<u>APPLICATION NO:</u>	20/00063/NMA2	<u>CASE OFFICER:</u>	Jo Sheridan
<u>WARD:</u>	Halewood South	<u>PARISH:</u>	Halewood Town Council
<u>LOCATION:</u>	Plot 2 - Land To North Of Railway Line Bounded By Lower Road Greensbridge Lane And Ditton Brook Watercourse, Halewood; And Plot 4 - Land To South Of Railway Line Bounded By Finch Lane, Baileys Lane And Higher Road, Halewood		
<u>PROPOSAL:</u>	NON-MATERIAL AMENDMENT FOLLOWING THE GRANT OF PLANNING PERMISSION 20/00063/FUL (RESIDENTIAL DEVELOPMENT FOR THE ERECTION OF 413 NO. DWELLINGS COMPRISING; PLOT 2 - ERECTION OF 98 NO. DWELLINGS AND THE CREATION OF VEHICULAR ACCESS FROM GREENSBIDGE LANE; PLOT 4 - ERECTION OF 315 NO. DWELLINGS AND THE CREATION OF VEHICULAR ACCESS FROM BAILEYS LANE; TOGETHER WITH ASSOCIATED WORKS (LANDSCAPING, ACCESS, ROADS, SEWERS, SUBSTATIONS, DRAINAGE, ENGINEERING WORKS TO FORM SURFACE WATER STORAGE AREAS AND OTHER INFRASTRUCTURE) - AMENDMENT SOUGHT TO ALLOW FOR CHANGES TO APPROVED PLANS COMPRISING OF REVISED VEHICULAR ACCESS TO SWALE AND RESITING OF SUBSTATION

The application seeks to make a non material amendment to 20/00063/FUL for the following:

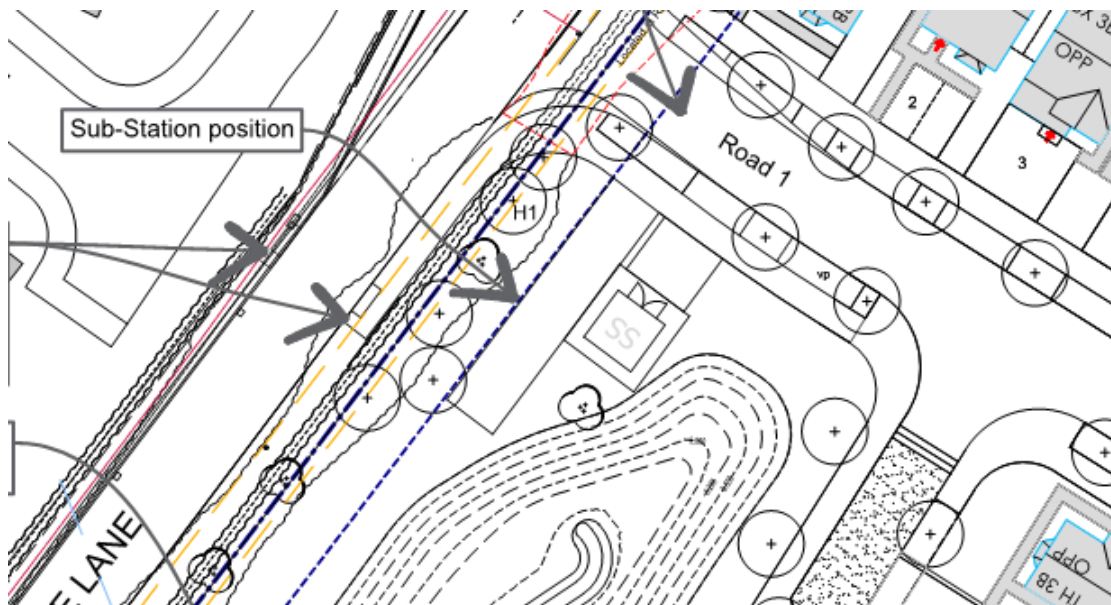
A vehicular access has been added to access the swale.

The location of the substation has been moved to the east to accommodate the vehicular access to the swale.

The location of the substation has been moved to the east to accommodate the vehicular access to the swale. The siting of the sub station is only slightly to the east of where it was originally proposed. The proposed amendments would be acceptable in terms of their visual impact and would not impact on the highway or residential amenity any more than the approved scheme.

A vehicular access has been added to access the swale to ensure the swale can be accessed by maintenance vehicles. The Highways Advisor has raised no issues regarding the access. As a result of the insertion of the access, the substation has had to be slightly relocated – see below.

Regarding highway safety, the proposed swale access modifications are acceptable as vehicle movements are expected to be infrequent, but, the new arrangements will prevent maintenance vehicles parking on street, which is welcomed.

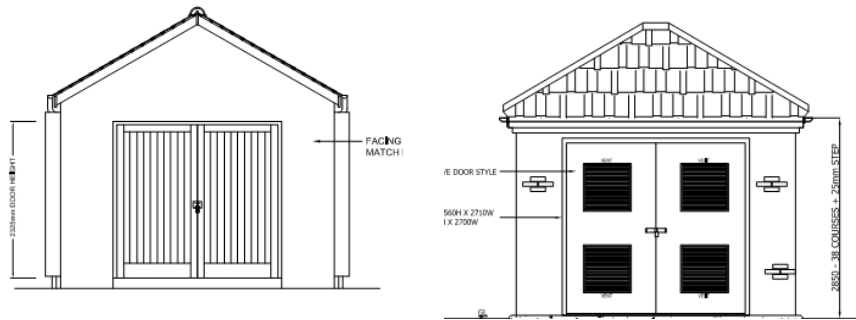
The sub station would be 4m wide; 4m deep; 2.64m high to the eaves and 4m high to the ridge. The roof would be pyramidal. The previously approved sub station was 4m wide;3.6m deep; 2.6m high to the eaves and 4.1m high to the ridge. The roof was pitched.

The footprint of the substation is slightly larger than the previously approved substation. The overall height remains largely the same at 4.1m. The roof has been amended from a pitch to a pyramid roof.

2. The substation hereby permitted shall be constructed using the following materials:

Brick - Manchester Brick Barcombe Blend

Roof Tile - Marley Modern Duo Smooth Grey

Doors - Black
